JNU: GLACIER HWY MULTI-USE SEPARATED PATH TO UAS

PROJECT No. 0933037 ~ 69500

Change Order

Project No.: 69500/0933037 Change Order No. 20

C.O. No. 14

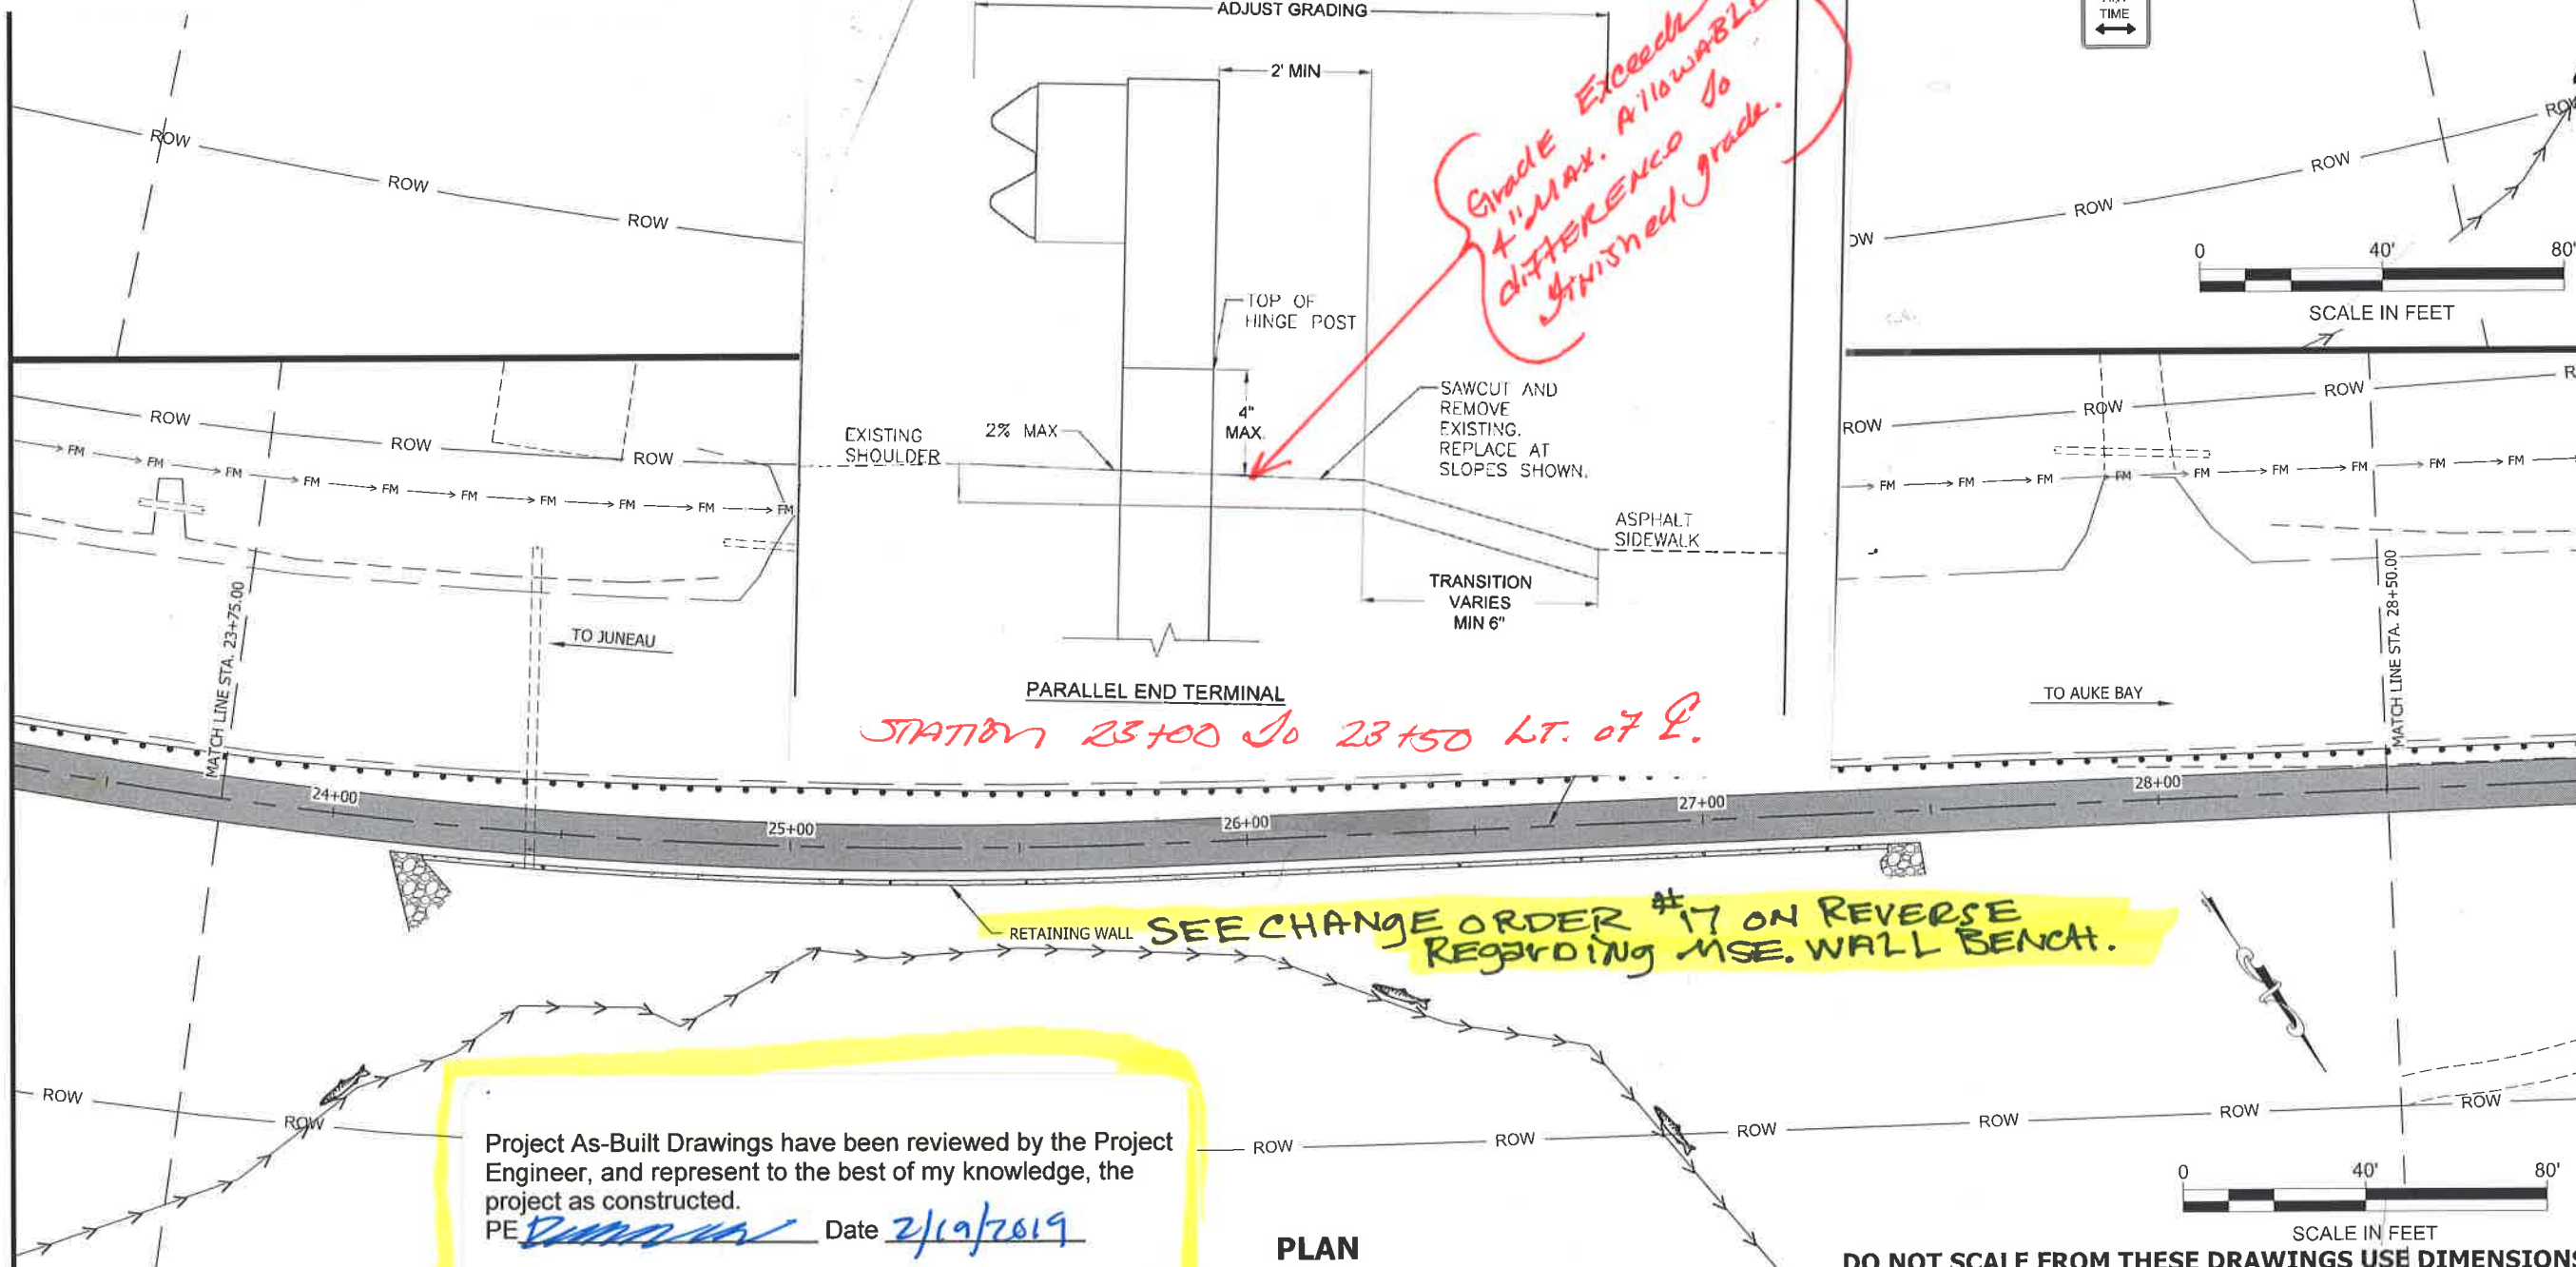
STATION 23+00 TO 23+50 LT. OF R.
